**STATE OF HAWAII
DEPARTMENT OF TRANSPORTATION
HIGHWAYS**

**ADDENDUM NO. 1
FOR
KAUMUALII HIGHWAY DRAINAGE IMPROVEMENTS
VICINITY OF OMAO STREAM BRIDGE
DISTRICT OF KOLOA
ISLAND OF KAUAI
FEDERAL-AID PROJECT NO. ER-27(008)**

October 22, 2026

DRAINAGE SECTIONS

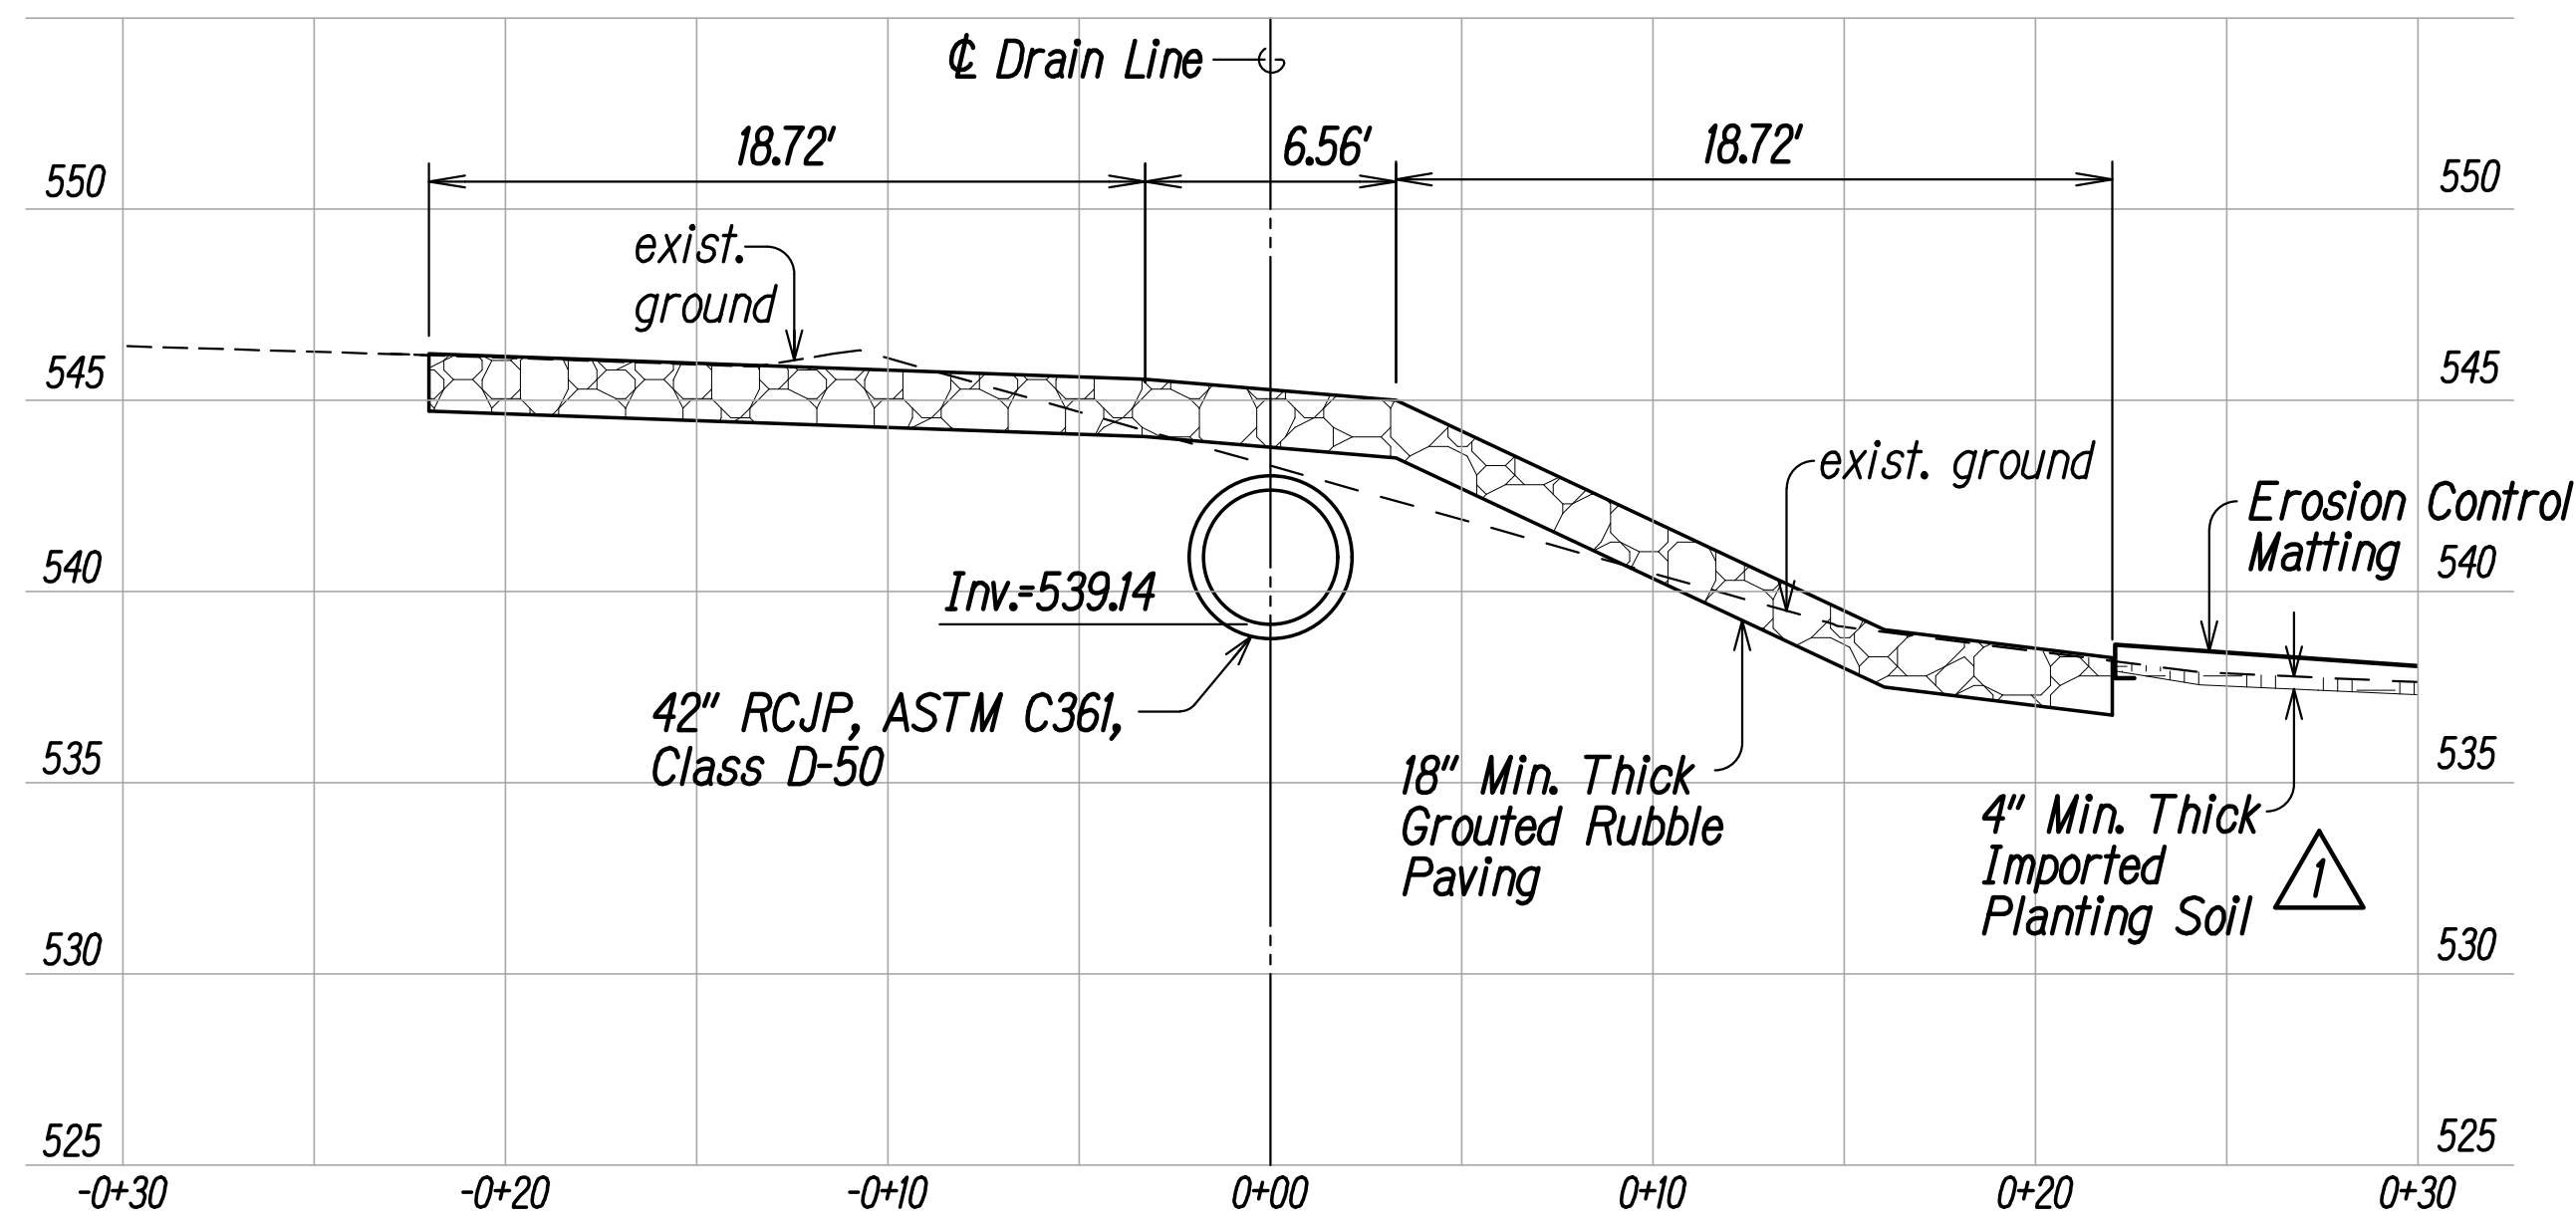
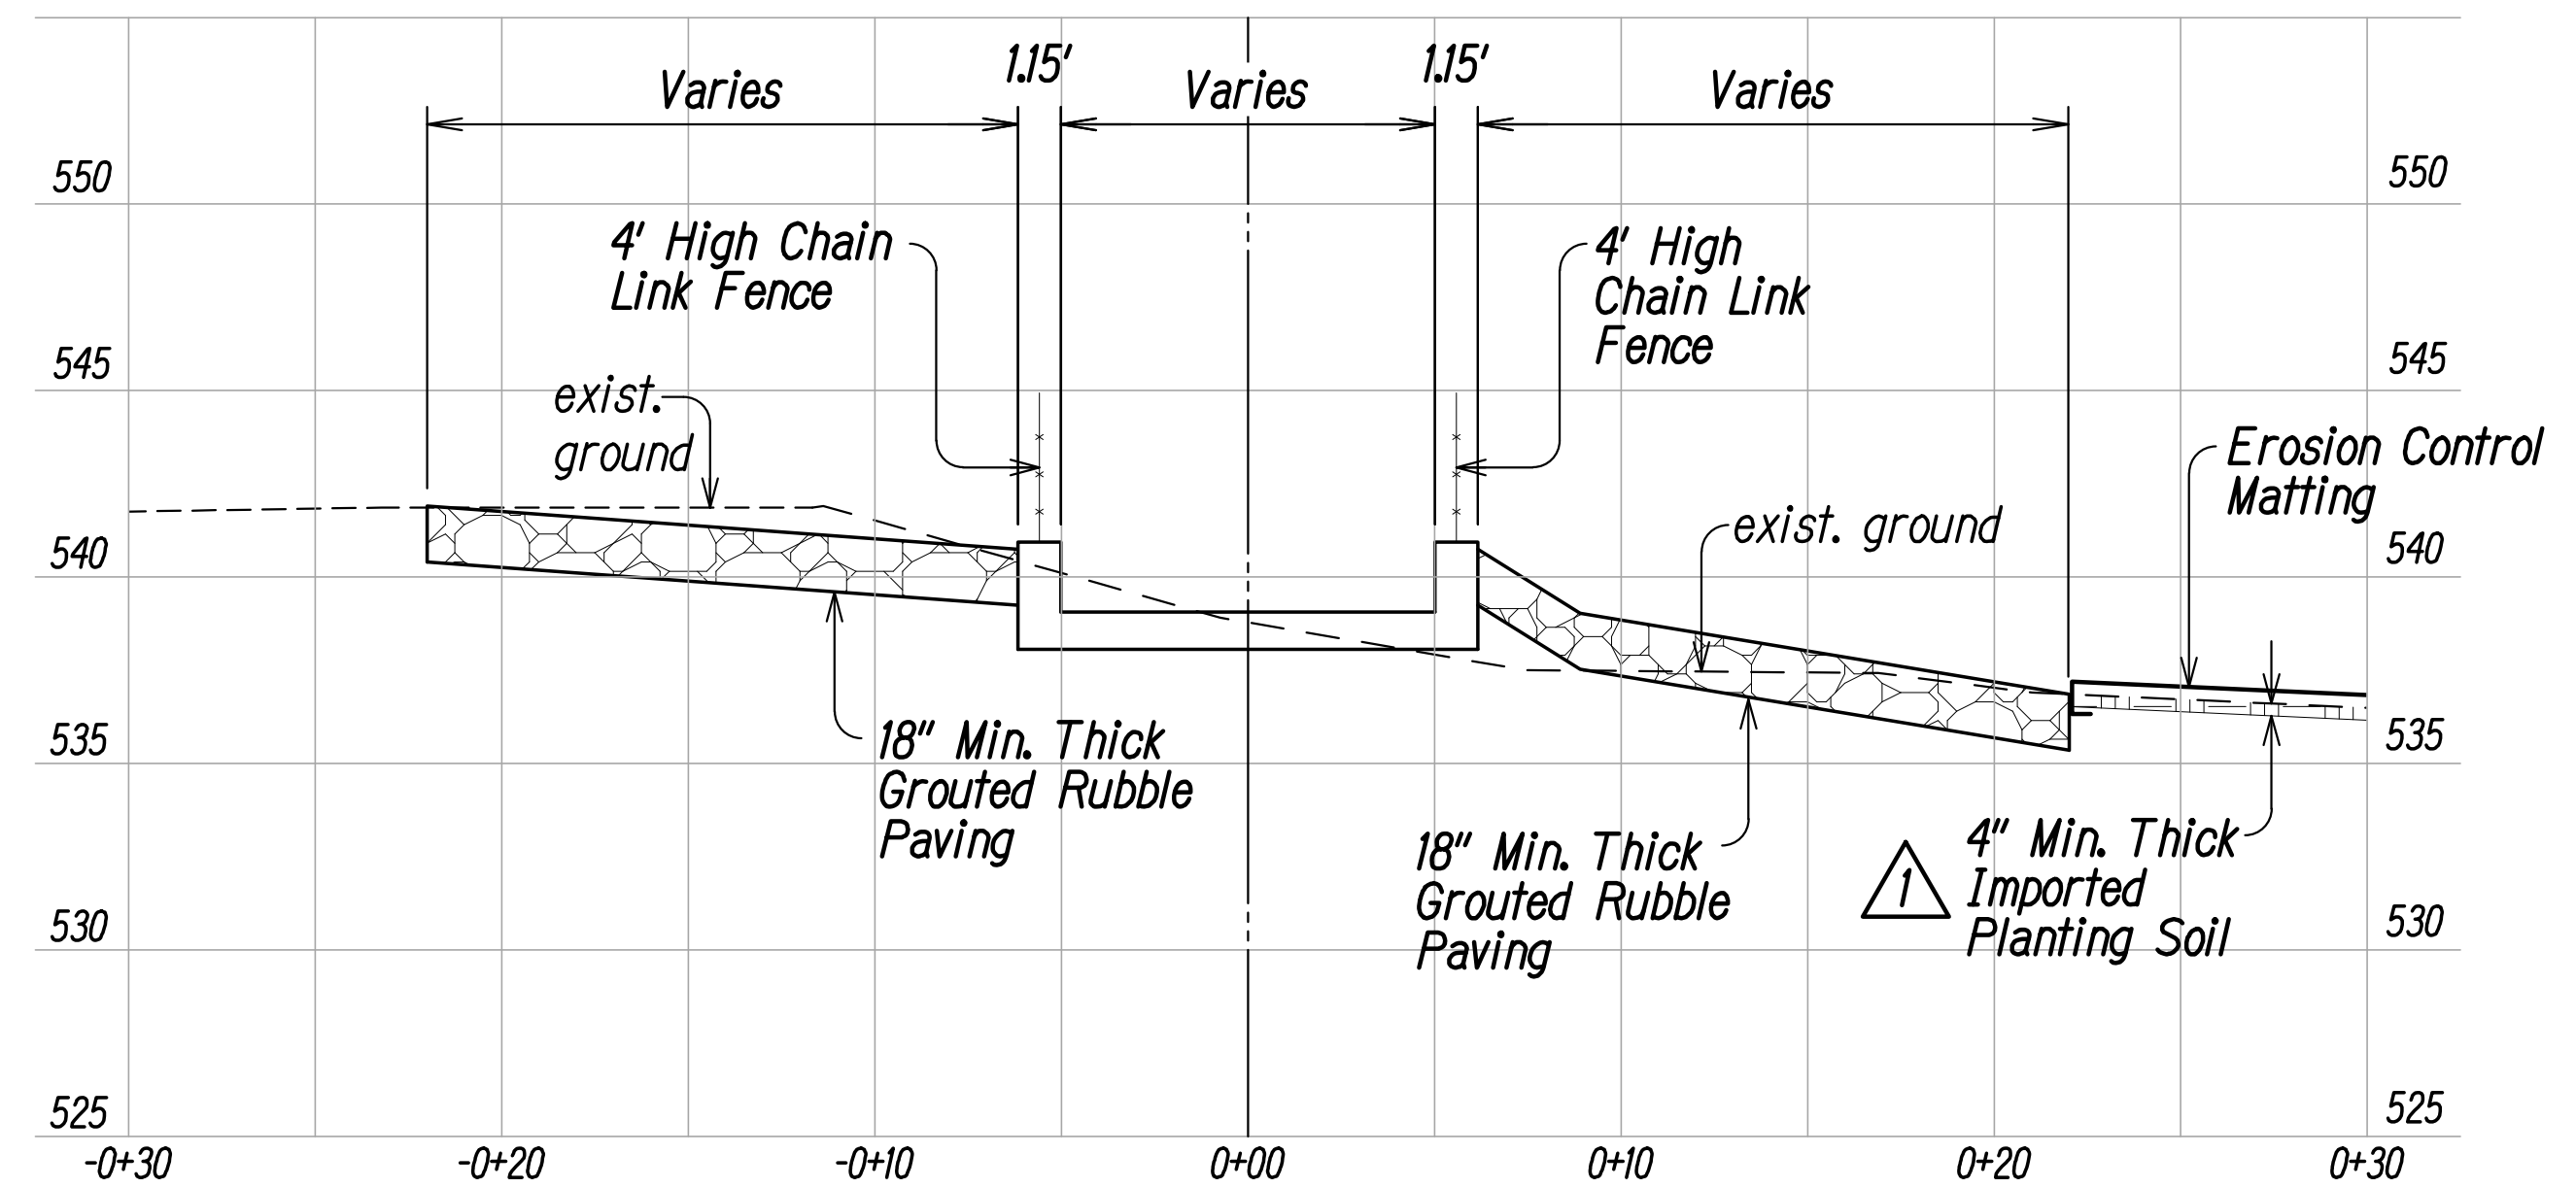
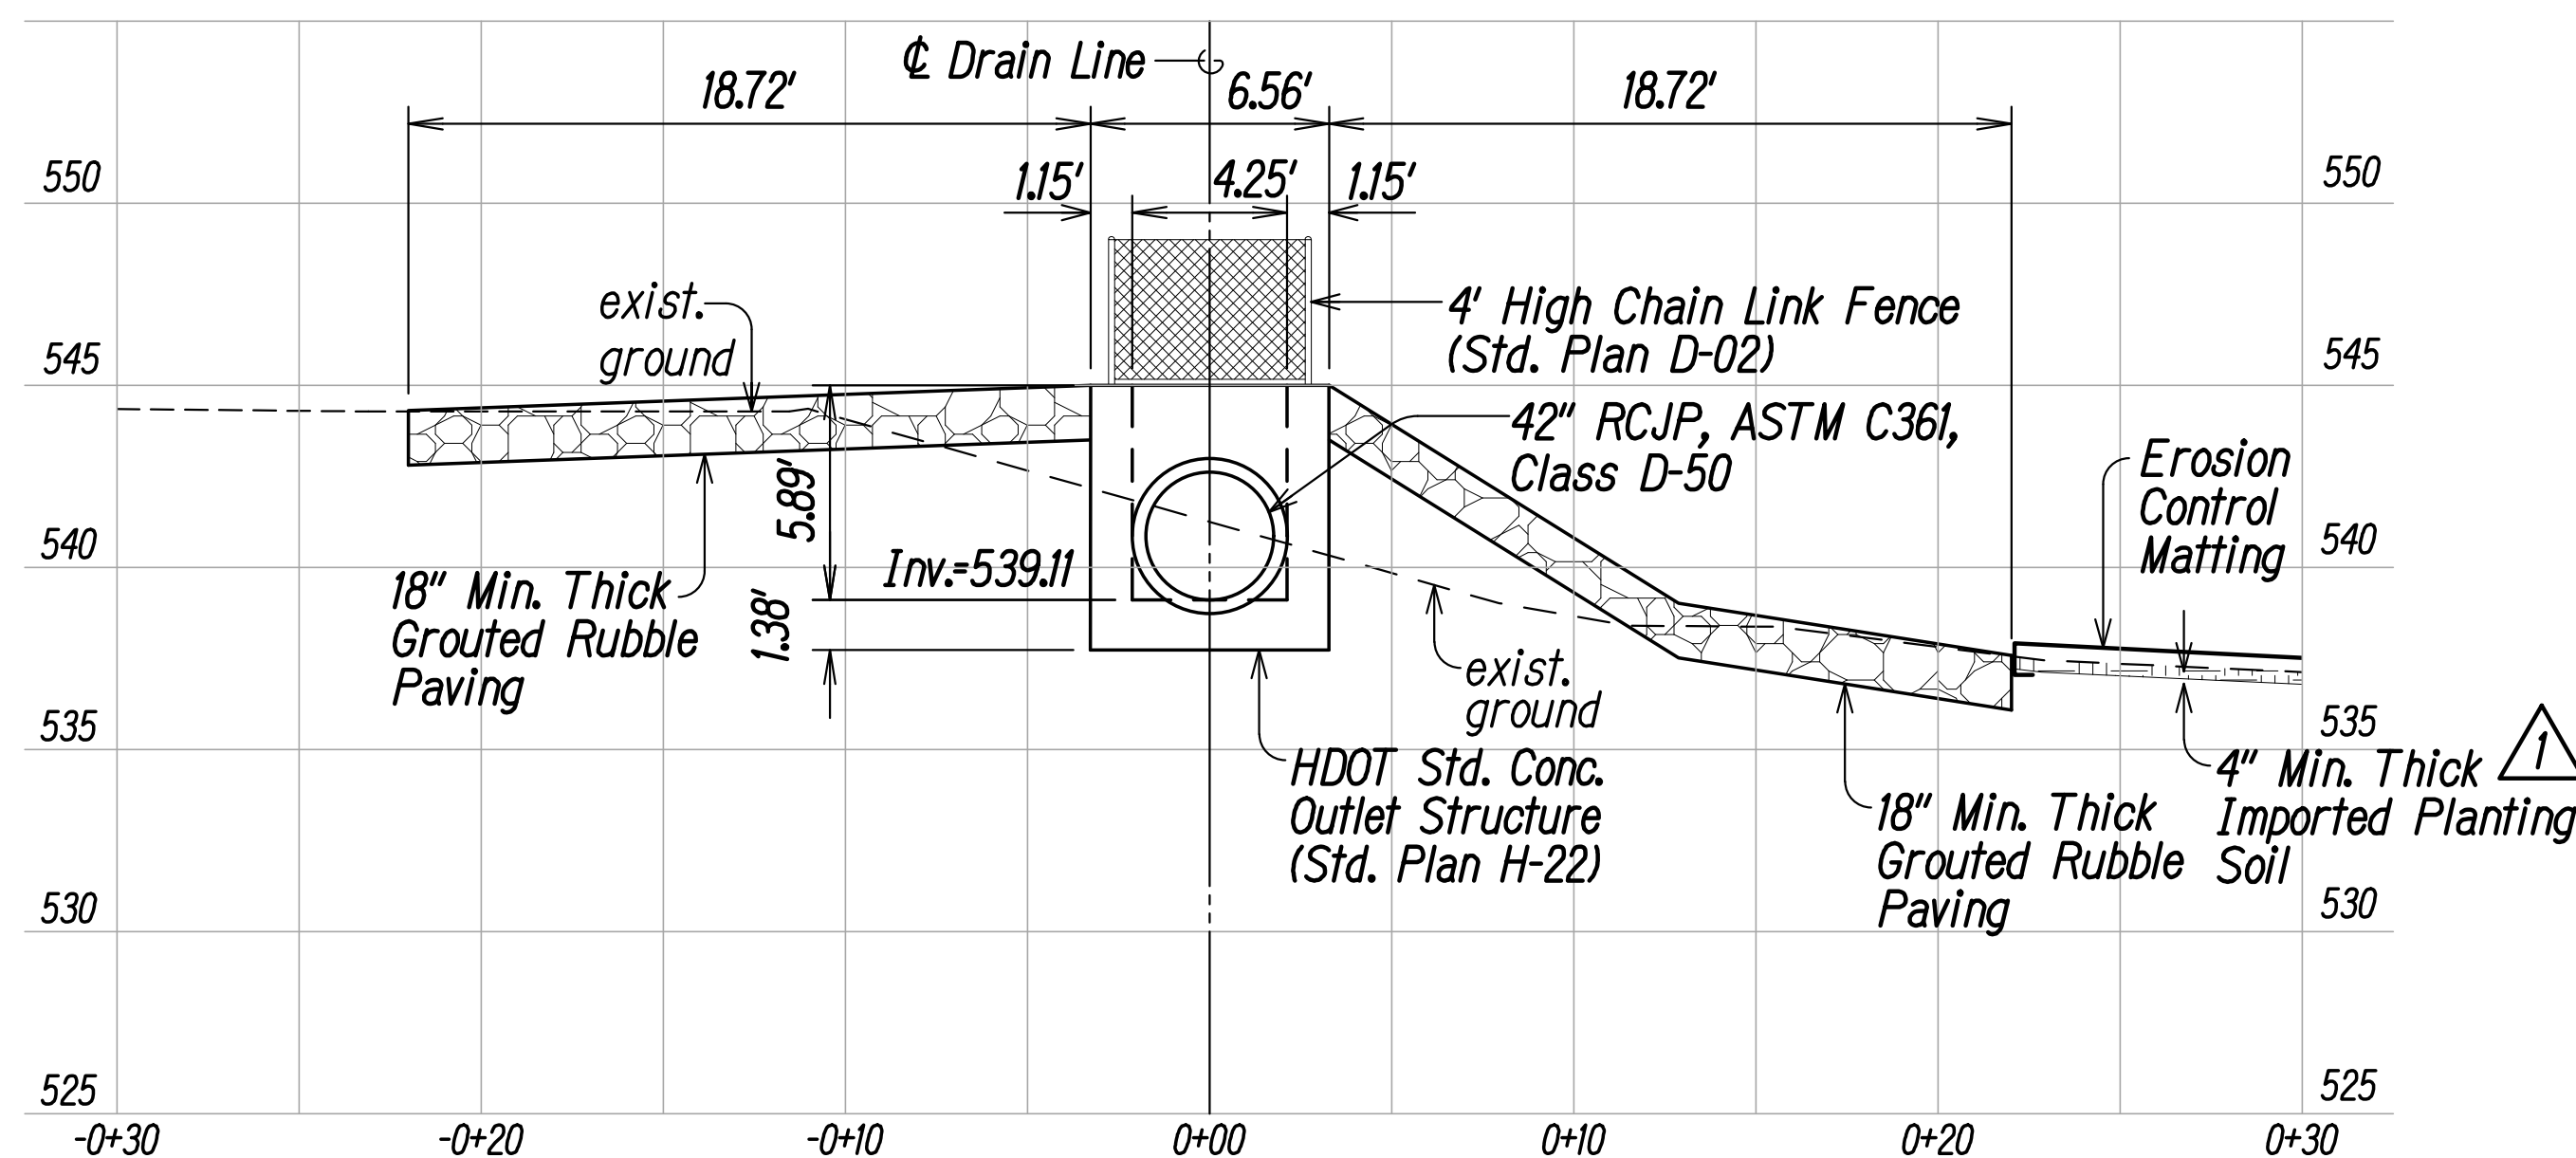
10/22/26 Revised sections to show 4" thick imported planting soil and grass.
